SUBJECT: WESTINGHOUSE RESPONSES TO NRC REQUESTS FOR ADDITIONAL
INFORMATION ON THE AP600

Response to Follow-on Questions Pertaining to Severe Accident Hydrogen Generation and Control

Response to RAIs 492.6 and 492.7

Case X4J - 4.75 Hot Leg Break with 2 Stage 4 ADS and 2 Accs
—— TCRHOT 0 0 0 Peak Core Temperatur

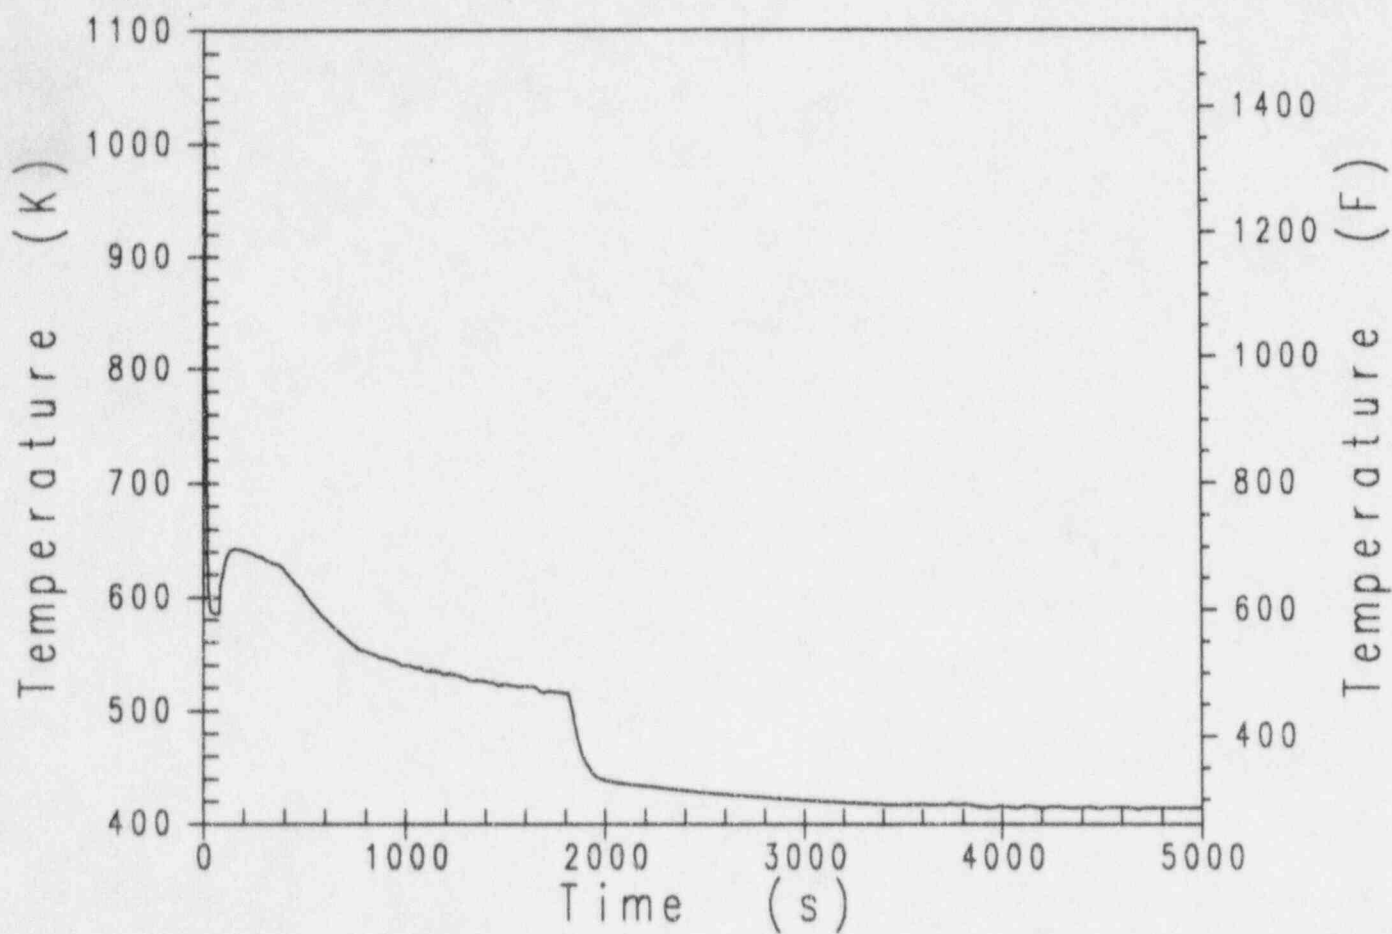
The following information is in response to the NRC's request for additional information on MAAP4 case x4j and a revised case m5f3. Specifically, the cases are:

A list of the requested plotted output parameters is contained in Table 1. In addition to the plot data, summaries of actuation times are provided in Table 2 and Table 3. The two requested scenarios are similar, but core uncover and heatup results are different due to the effect of the accumulators. In the 4.75" hot leg break, the RCS depressurizes such that the 2 accumulators inject as soon as the core starts to uncover. The accumulator injection recovers the core, and there is no noticeable impact on core temperatures.
